Product/Process Change Notice (PCN)

PCN Number #: ConUSB_20150812

Product Affected: 62900416021

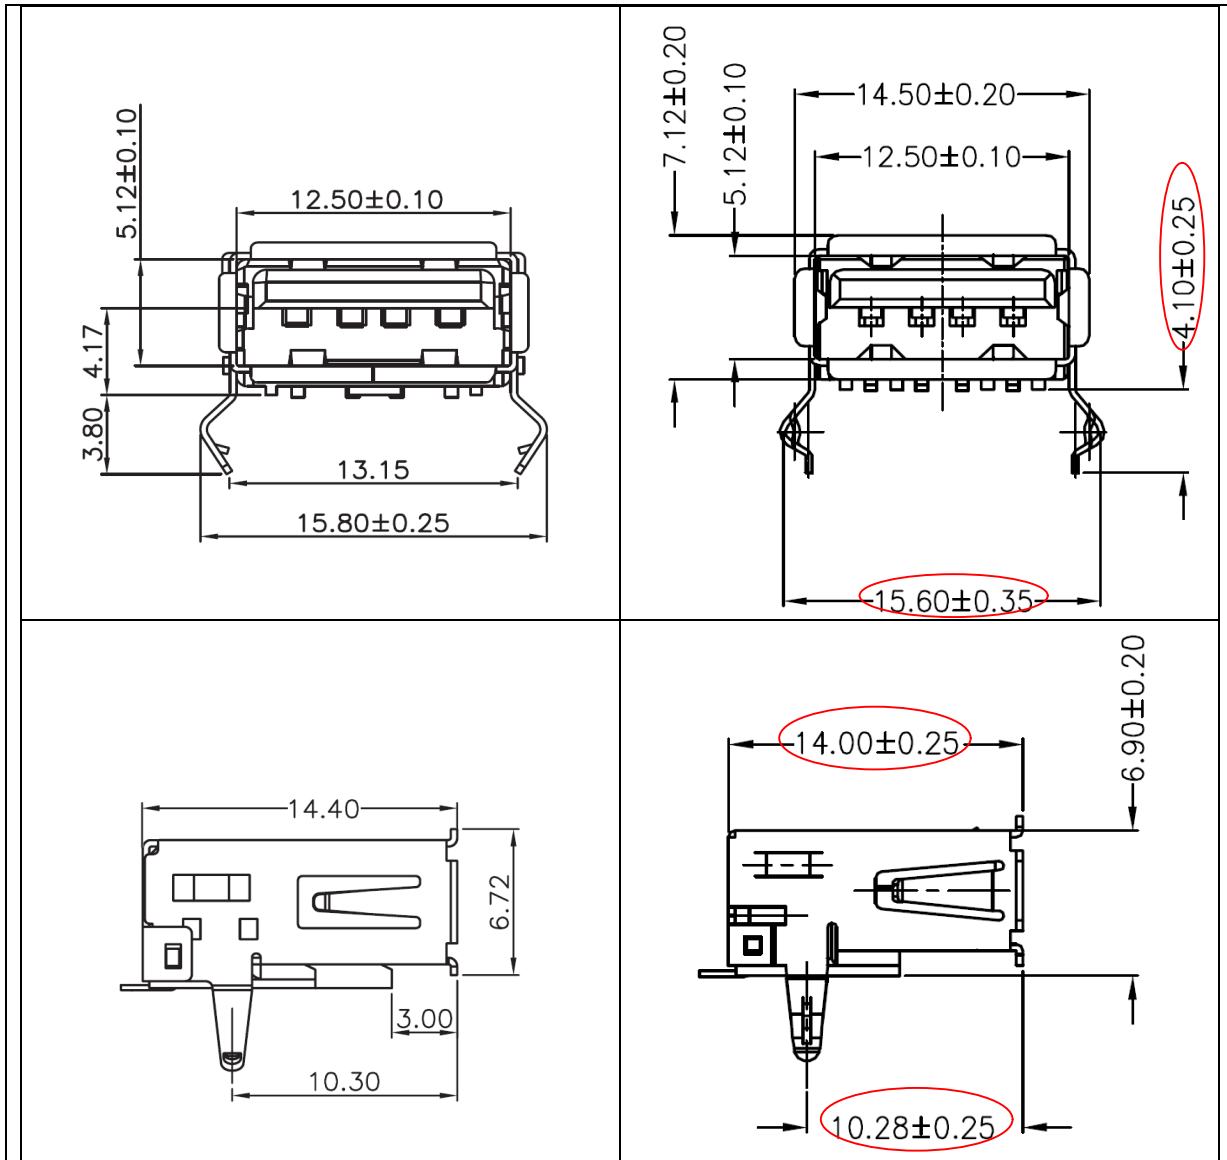
- A fully automatized process will be implemented and CCD inspection controls will be added. The design changes can be found in the datasheet. They are summarized below and marked in red:
